ADDENDUM NUMBER TWO (2)

December 22, 2025

PROJECT: DNR-250011

Dillon Visitors Experience Enhancement
5265 Dillon Hills Dr., Nashport, Ohio 43830

SITE FENCE HEIGHT PLAN
 CONSTRUCTION DOCUMENTS SET

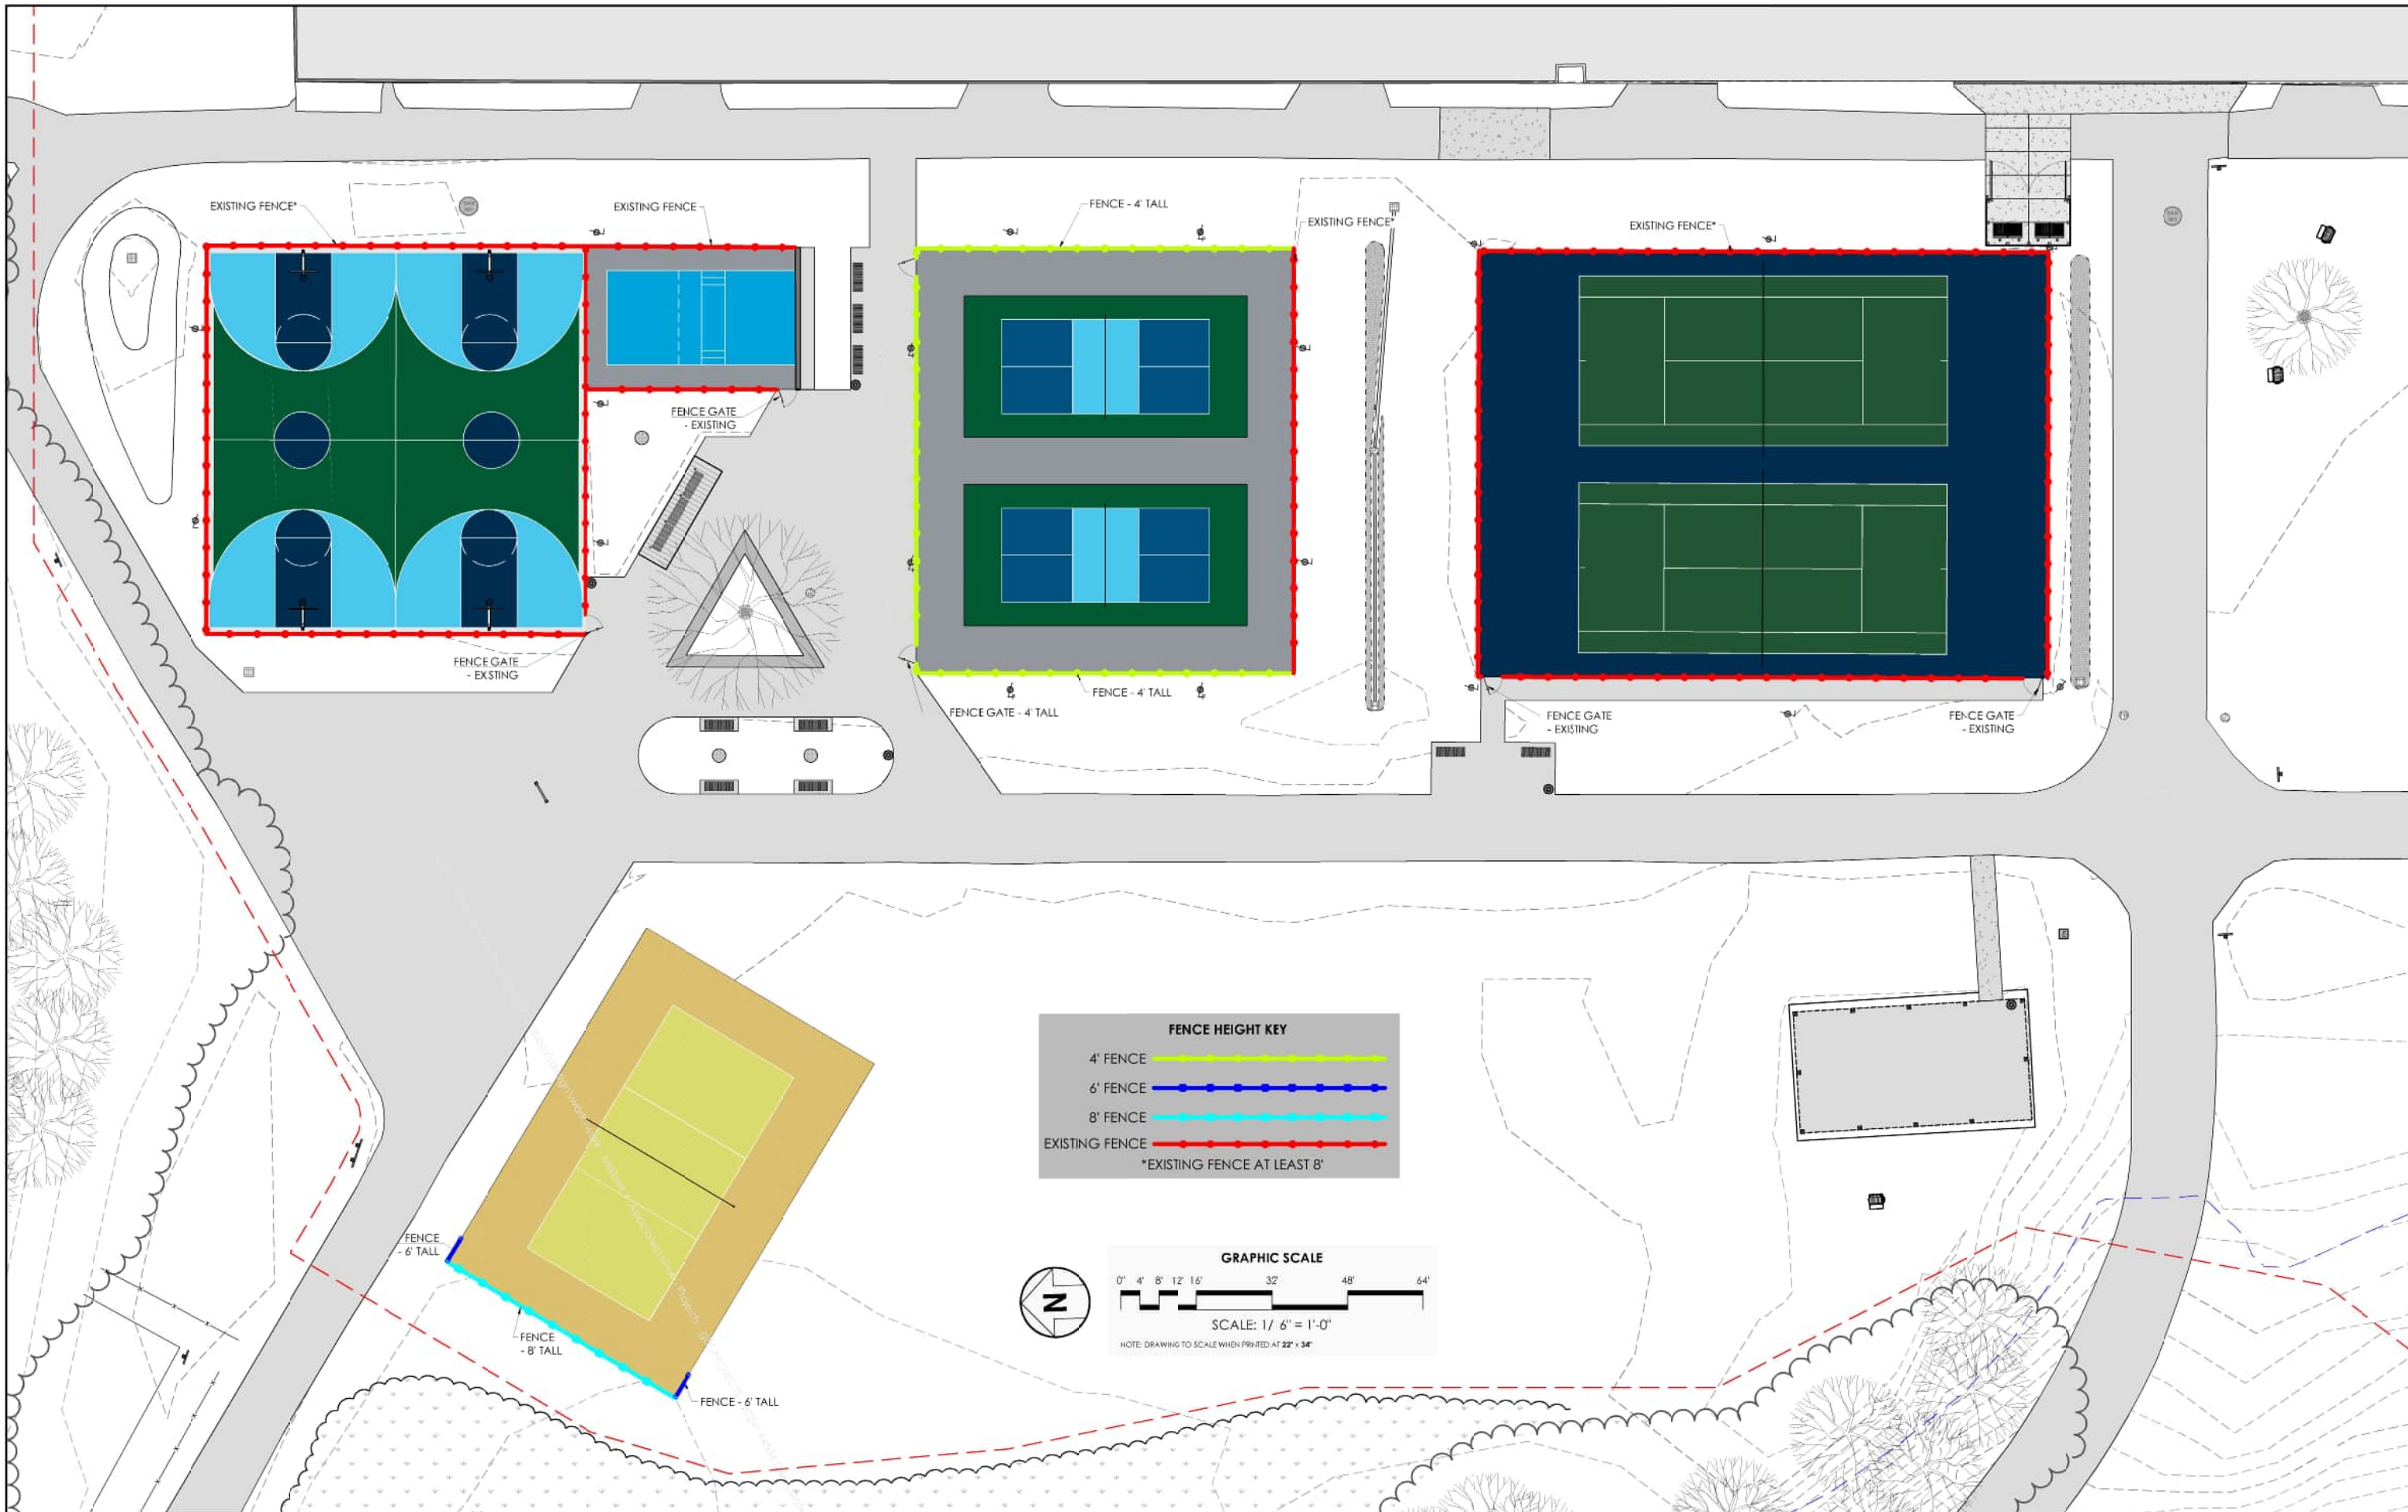
- RFI-1.** The fencing around the sports courts is showing two different heights of fencing a 4' fence with a 6' Gate. What is the height of the sport courts fencing?

Response: Please see attached drawing. All existing fences that are to removed, shall be salvaged, painted, to match existing, and reinstalled. If Contractors would prefer to remove them and install new fences that would be acceptable.

D (TYP.) PLUMBING CHASE DETAIL FOR INSTALLATION OF WATER CLOSET
N.T.S.

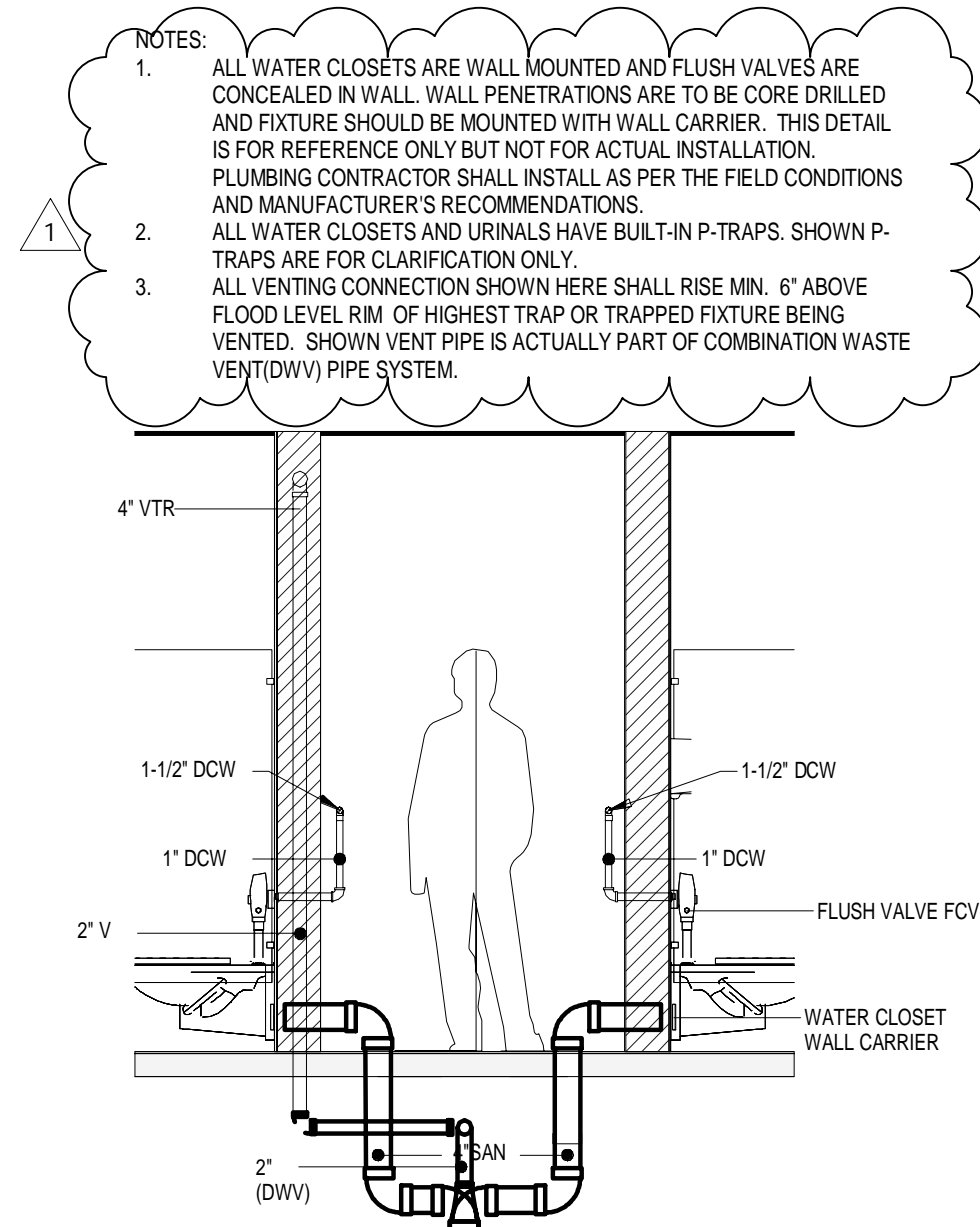
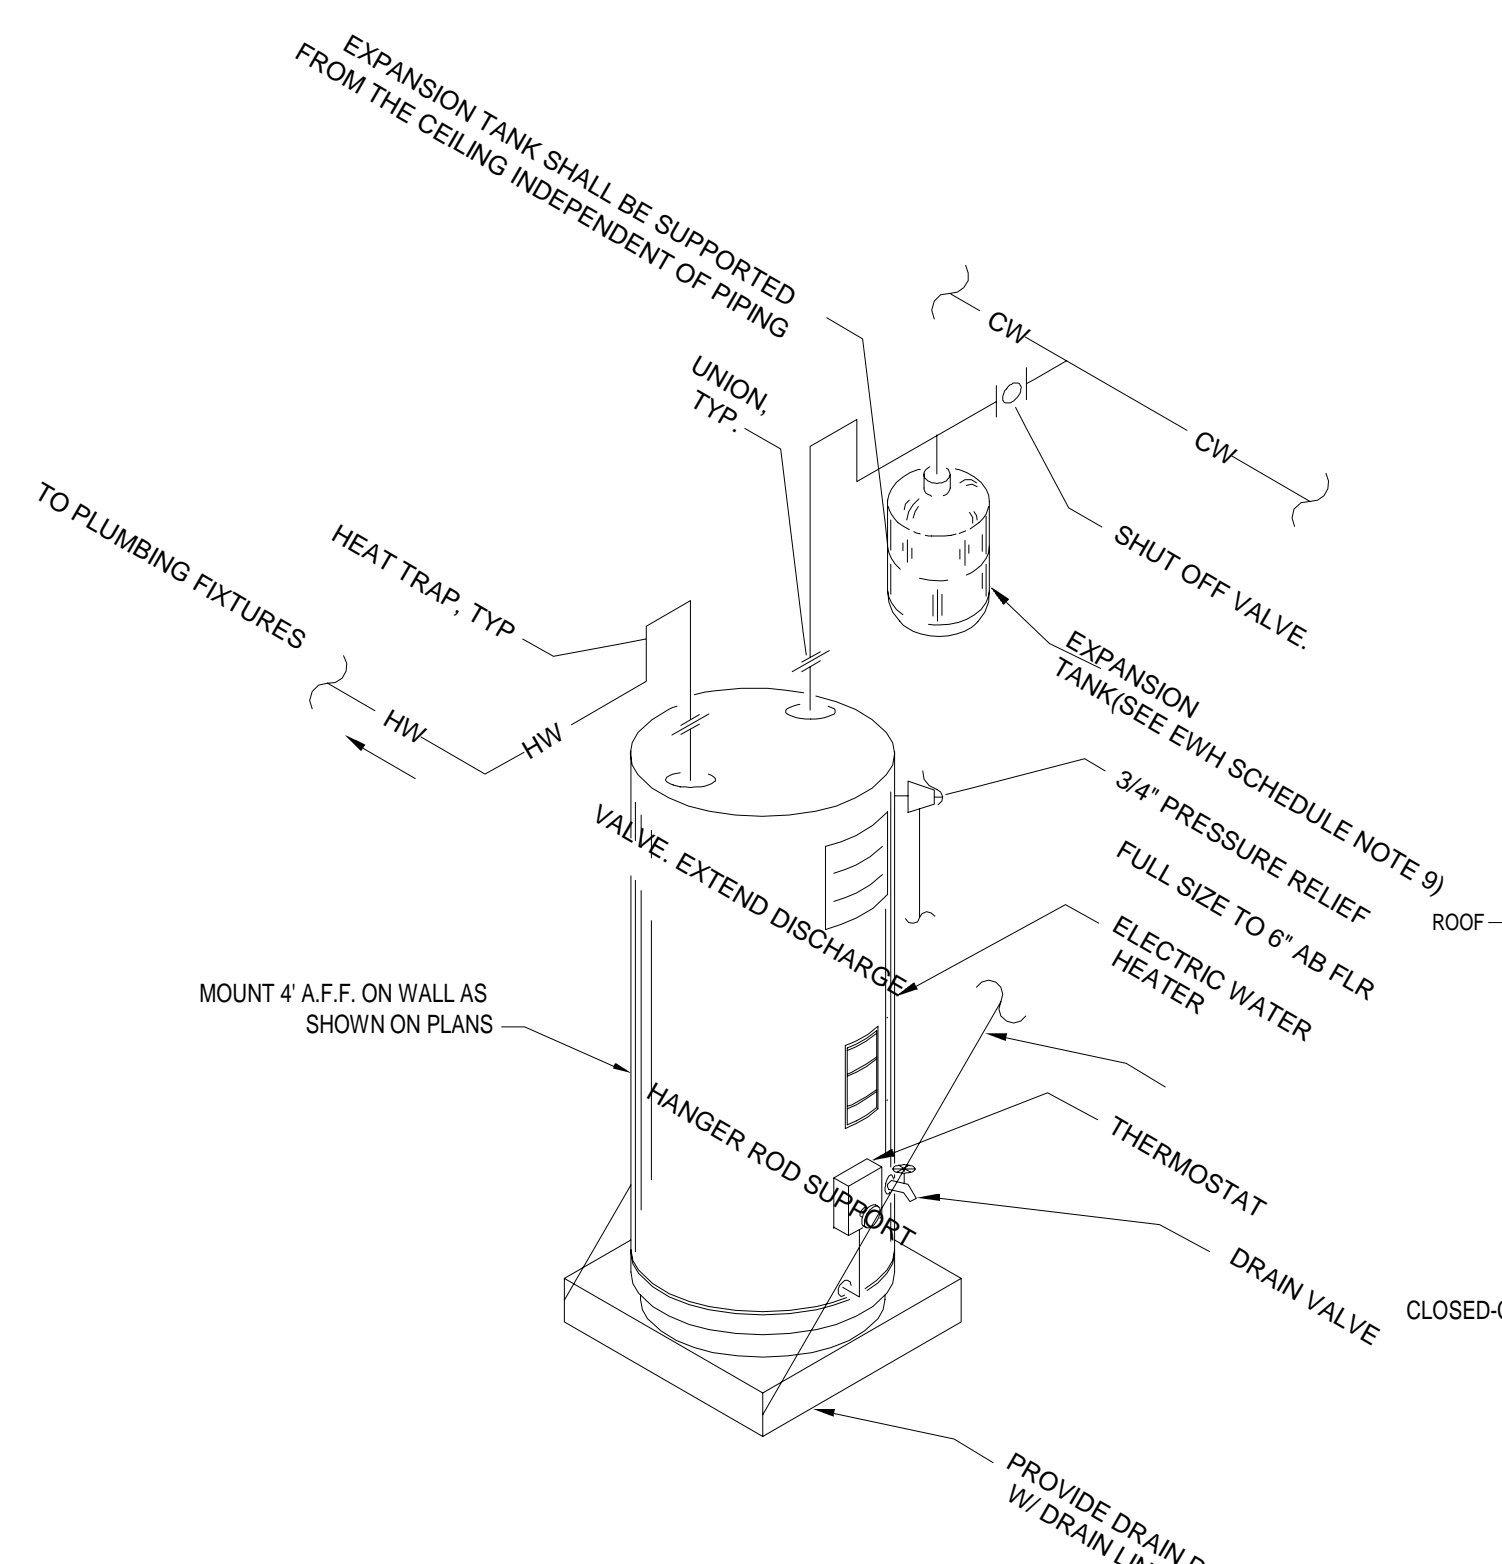
- D-01. Revised Civil, Doors schedule, and structural drawings “Clouded changes”
- D-02. Toilet Fixtures shall be Wall Mounted, see revised P.501 and P.601.

NOTES:
1. ALL WATER CLOSETS ARE WALL MOUNTED AND FLUSH VALVES ARE CONCEALED IN WALL. WALL PENETRATIONS ARE TO BE CORE DRILLED AND FIXTURE SHOULD BE MOUNTED WITH WALL CARRIER. THIS DETAIL IS FOR REFERENCE ONLY BUT NOT FOR ACTUAL INSTALLATION. PLUMBING CONTRACTOR SHALL INSTALL AS PER THE FIELD CONDITIONS AND MANUFACTURER'S RECOMMENDATIONS.
2. ALL WATER CLOSETS AND URINALS HAVE BUILT-IN P-TRAPS. SHOWN P-TRAPS ARE FOR CLARIFICATION ONLY.
3. ALL VENTING CONNECTION SHOWN HERE SHALL RISE MIN. 6\"/>
